| 8802-3/802.3 REVISION REQUEST 1158 |

REQUESTED REVISION:
STANDARD: IEEE Std 802.3ah-2004
CLAUSE NUMBER: 65.2.3.2.3
CLAUSE TITLE: Special frame markers

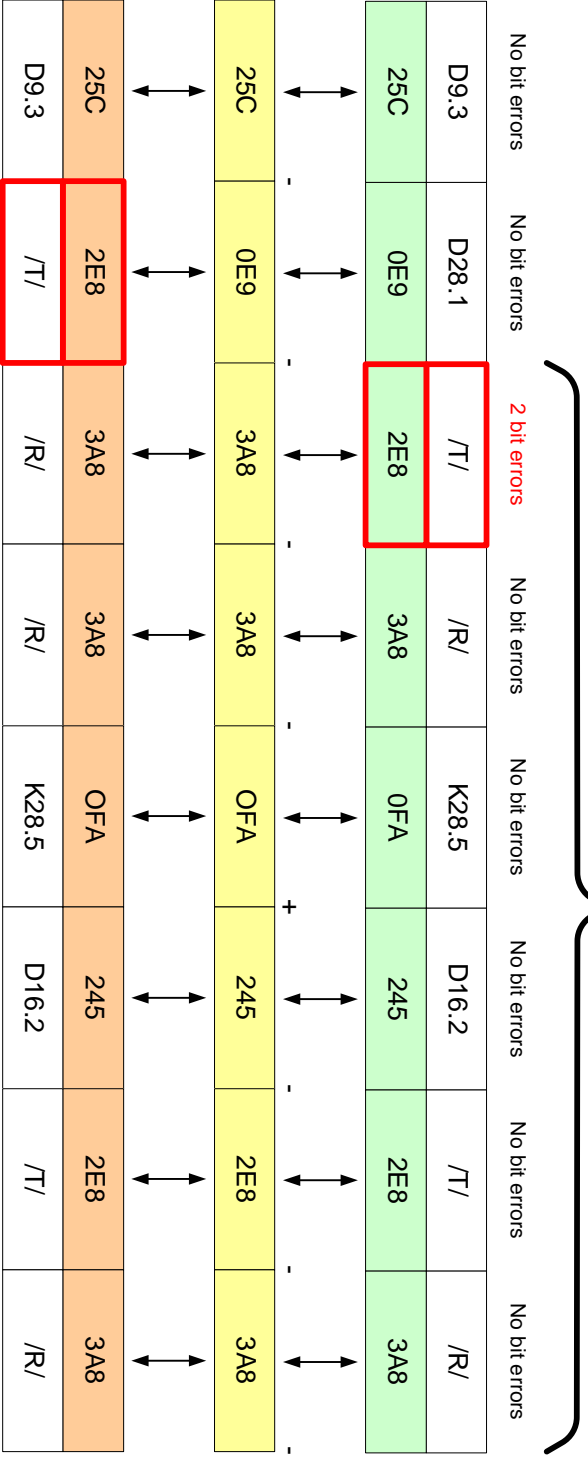
The FEC state machine looks ahead at the incoming bit stream and attempts to match 6 or 7 bytes to T_FEC_E or T_FEC_O. The match is declared is if received bit stream has Hamming distance of less than 6 from the bit sequence specified for T_FEC_O or T_FEC_E delimiters.

The problem is that T_FEC_E and T_FEC_O are only Hamming-distance 2 apart, and can be easily confused. The attached diagram shows an example where both T_FEC_O and T_FEC_E could be matched with only 2 bit errors each.

The FEC receive state machine can easily mistake Dx.x+T_FEC_E for T_FEC_O. When this happens, the FEC receive state machine discards the last byte of CRC32.

Page 2 in the attached diagram shows the increased Hamming distance when a modified T_FEC_E is used.

Correct match = T_FEC_E (2 bit errors)

Incorrect match = T_FEC_O (2 bit errors)

802.3ah allows up to 5 bit errors

10 Bit Error over 60 bits correlation

Hamming distance between modified TFEC_E and original TFEC_O when starting running disparity is negative

10 Bit Error over 60 bits correlation

Hamming distance between modified TFEC_E and original TFEC_O when starting running disparity is positive

- /T_FEC_E/ - end of FEC coded packet with even alignment.
If the starting running disparity is positive,
the T_FEC_E has the following pattern: /T/R/K28.5/D10.1/T/R/

If the starting running disparity is negative,
the T_FEC_E has the following pattern: /T/R/K28.5/D29.5/T/R/
